From: Scala, Mary Joy
Sent: Monday, August 22, 2016 10:31 AM
To: Steigman, Trey; Stephen von Storch (svonstorch@s-vs.com)
Cc: Charlie Armstrong (CharlesA@southern-development.com)
Subject: BAR Action - Ridge and Cherry William Taylor Plaza 2- Aug 16, 2016

RE: Certificate of Appropriateness Application (Preliminary Discussion)
BAR 16-08-05
NW Corner of Ridge Street and Cherry Avenue (William Taylor Plaza)
Tax Parcel 290147000, 290146000, 290145000
Cherry Ave Investments LLC, Owner/ Management Services Corp., Applicant
New Construction of Residential Building

**CITY OF CHARLOTTESVILLE
BOARD OF ARCHITECTURAL REVIEW
STAFF REPORT
August 16, 2016**

**William Taylor Plaza
Planned Unit Development (PUD)
Phase 2 – Ridge Street Residential**

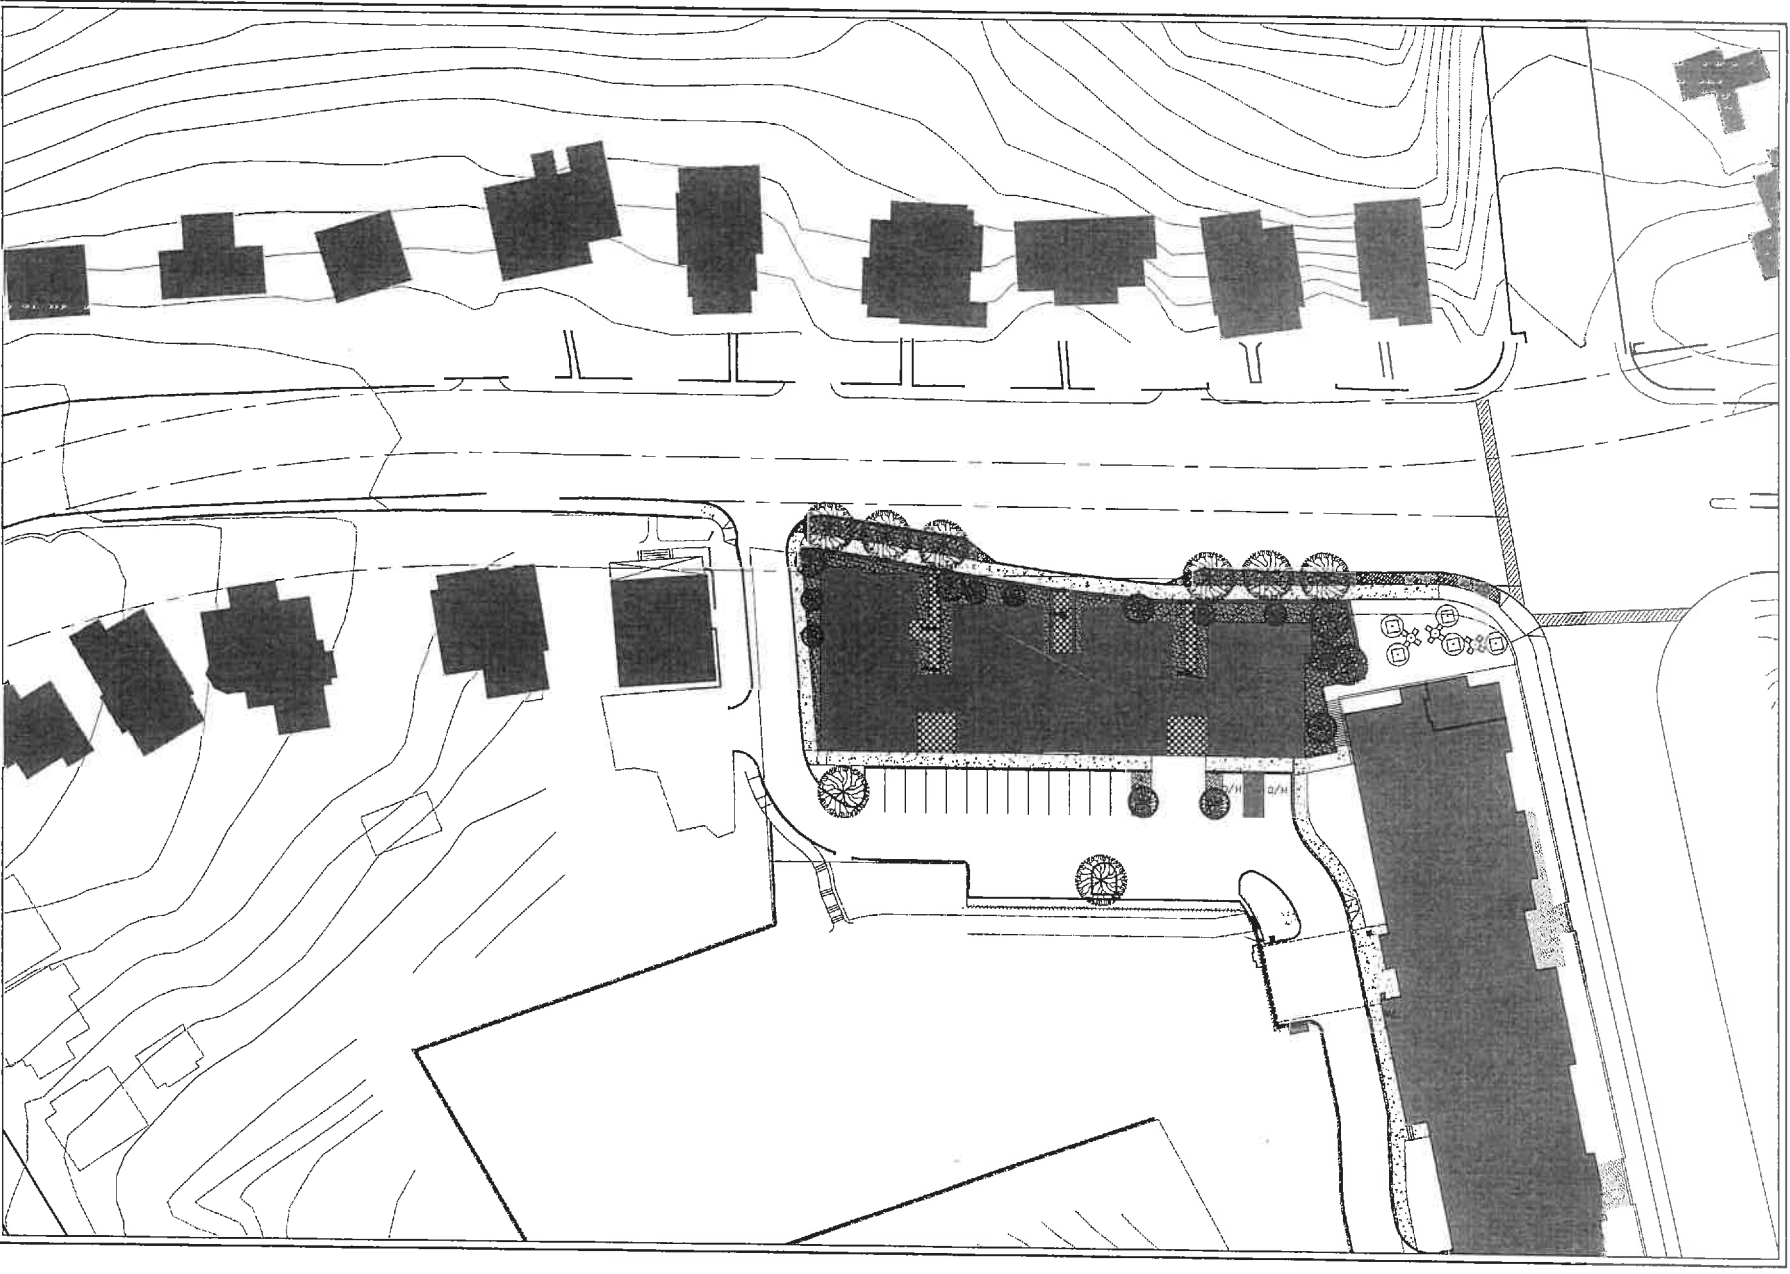
Miller: Overall, this site is way more important than the hotel site, in terms of its relationship to the historic district, and I think taking cues from Ridge Street are important. The overall massing and setback is still too much for the site and the historic district. The historic district has a feeling of verticality and space between the existing structures and your plan attempts this to an extent, but this feeling should be increased. Also, the feeling of a front door needs to be incorporated into the plan. In addition to the verticality look at larger bay windows and the idea of a front yard. The stair areas need to be lighter and more transparent, although that could just be your rendering. Also, I am not sure how this works into the scheme; there are a lot of hipped roofs, and that might help bring down the massing on some of the edge pieces. I think it is a nice thing to have all of the units (except for 2) to be accessible, but is that making this more difficult to deal with because of the connectivity?

Schwarz: I agree with a lot of the things that Melanie [Miller] said. Some smaller things, I am wondering where you have the two outer buildings that have the gables, but don't step back from the gables, if a small setback (even 4-8 inches) would create a break in the façade and help articulate it a bit more. I wouldn't have window boxes, because you can't make people plant flowers, and you have no idea of knowing what is going to be there. The columns on the porches, an entire stucco language makes it feel commercial and takes away from the residential feel. If you have more wood trim, creates a change in material, which would help create a residential sense in the structure. The parapet idea on the north edge has me a little bit worried that is not a place you want to bring the wall up any higher than it already is, so I would reconsider how you handle that flat roof and the mechanical equipment. I think you tried with the two and a half story thing to work, but I think you could go a bit further.

Keesecker: I think it is the appurtenance-like details that make Ridge Street district interesting. I think it is that mixture of details found on the historic homes that makes it visually appealing. I don't know how you do that in a larger footprint, without making it seem like a false front fake façade, but that is the key. I remember from the PUD that there were some outdoor areas dedicated to gathering, and I think all of those [outdoor] spaces that can be occupied will also aid in blending into the neighborhood. The façade that faces onto the courtyard, in context with the hotel should also be revisited. I think mixing up the ABBAABBA rhythm of the facades would help tremendously, making it less symmetrical.

Balut: I am going to start from a general design standpoint which I am confused about, it seems like it is between this new modern building and old late 19th century homes. I am having a hard time understanding the aesthetic identity of the building, I feel like it is in this in between place, and because of this it is not resolving a number of issues. Specifically, you are saying it is breaking down into volumes, but I feel like it is going to read as one volume, from the front and the back. I think varying the rooflines could help a lot with that. Currently, the spacing between the masses is not enough that it breaks the buildings apart. I think focusing on the little details and on symmetry versus asymmetry is minor, because the overall structures are lacking a cohesive identity and massing concept, if you could articulate what you trying to accomplish with the massing of the building that could inform a lot of these details. The human scale seems to be taking place on the interior of the building, but it might be nice to have something on the exterior that speaks to this scale.

Sarafin: To put a few specifics to what you are talking about, I remained unconvinced that the gable is the roof form of choice here. I am having a hard time moving beyond this tortured roofline.

Mohr: One thing I think would help is to have a longer rendering of the street, so you could see the overall sense of the street. What if conversely you take that center section, pull those two things apart and make it more like a courtyard entry? The amount of wall to window ratio on the older houses is much less glass with simpler punctures, the scale of the openings feels almost 3/4 scale even though it is taller because they have a greater wall to window ratio. Maybe taking a totally different approach with the center building would help break up the massing a little bit. The only other thing is on the courtyard elevation, get rid of that opposing gable and extend the roof the whole way through.

Knott: I am not hearing enough of how your design was influenced by the precedence of the physical characteristics of the district. I made a list of things that I saw on Ridge Street: a consistently large set back, a layering of spaces from public to private, variety of roof lines, windows centered in different parts of the building, bay windows, porches, defined entrance with a clearly prominent front door, etc. What I am seeing here is a lack of concept. Another point, in the PUD drawing, it really reads as individual townhouses and it is more of a residential cluster of buildings, and I think this design lacks that residential feeling. Also, in terms of the setback it seems simple to achieve a graceful setback by setting the northern most building back by about 8-10 feet, that way it doesn't create such a hard edge, and then the third volume could setback 5 feet. That way there is a more acceptable setback that allows for more layering of spaces with the streetscape. The last point I wanted to make is the stairs in between each section remind me of the stairs you would see on the back of the buildings on Ridge Street and it doesn't seem appropriate on the street front. I would prefer a treatment like the center opening where the main entrance is rather than seeing those stairs there because it reminds me of a back door.
